# CONSULTANT ADVICE NOTICE

**PROJECT: DUNDAS PUBLIC SCHOOL UPGRADE**

**CAN NO: G-002[1.1]**

## PRELIMINARY ENERGY MODELLING ASSESSMENT

DRAWING NUMBER	REVISION
DUPS-FTA-B00L-GF-DR-A-2101	P1

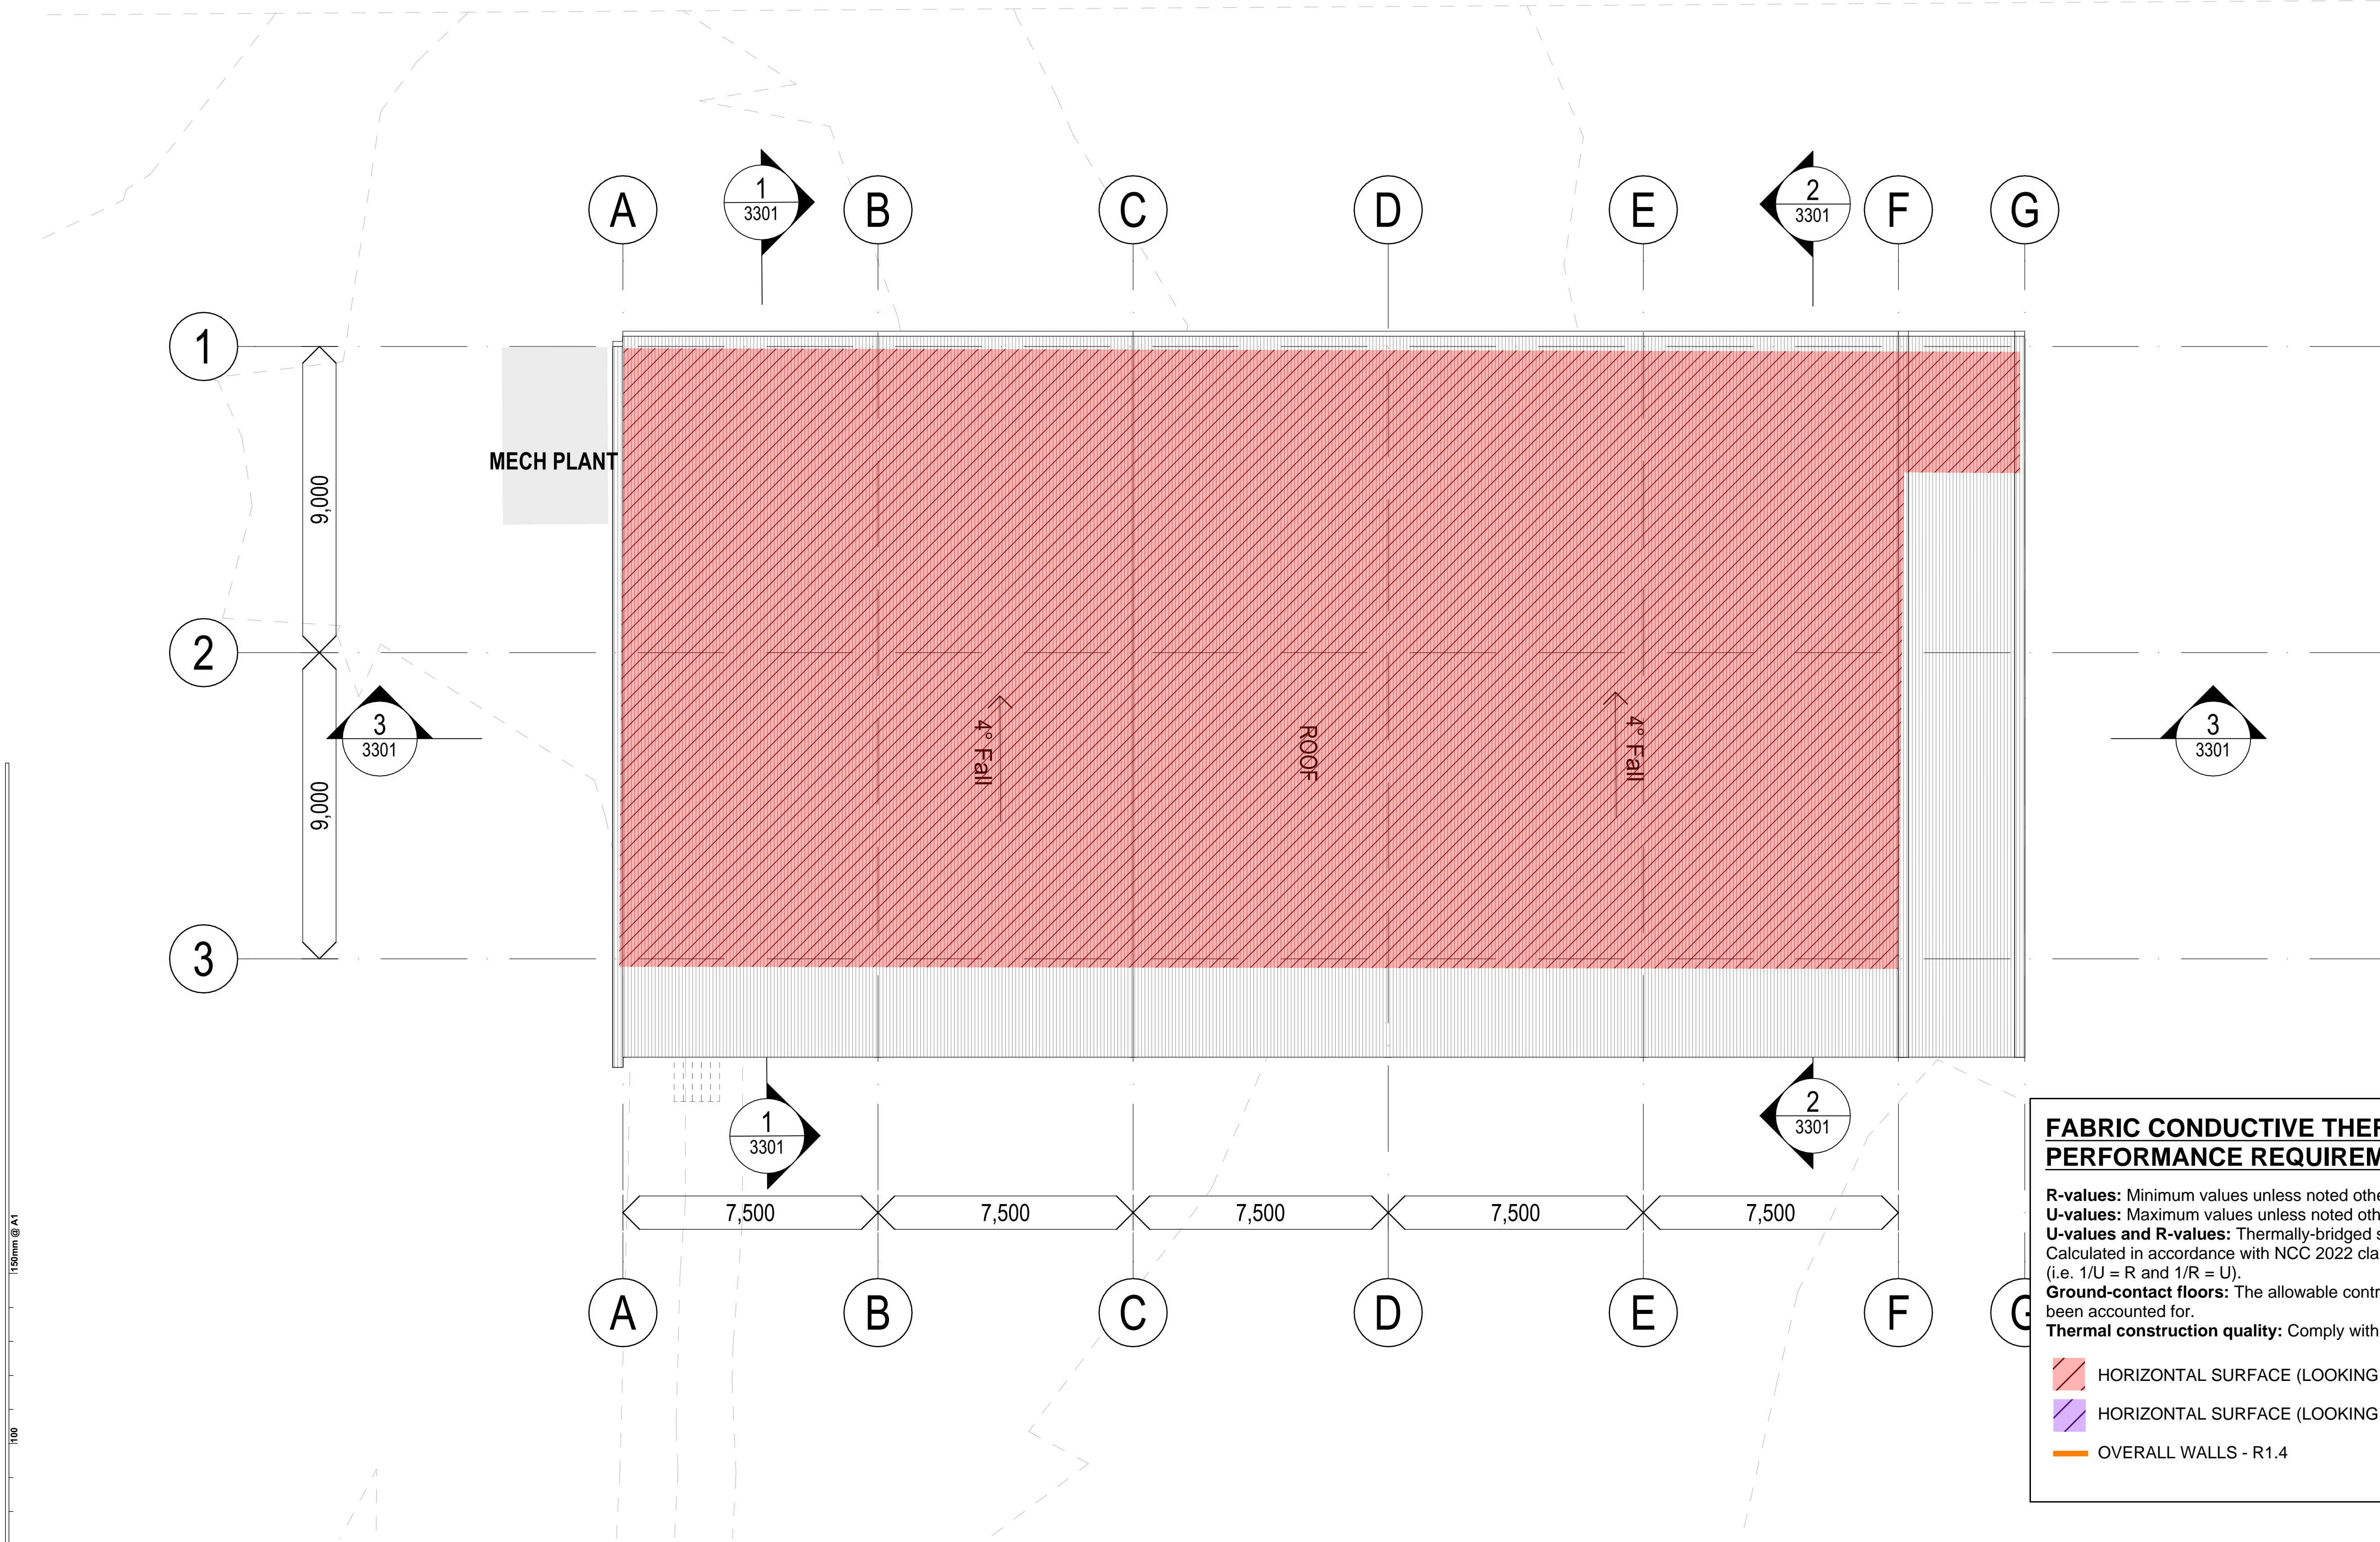
## APPENDIX A: THERMAL ENVELOPE MARK-UP

- HORIZONTAL SURFACE (LOOKING DOWN): R3.2 [UPWARD HEAT FLOW]
- HORIZONTAL SURFACE (LOOKING DOWN): R2.0 [DOWNWARD HEAT FLOW]
- OVERALL WALLS - R1.4
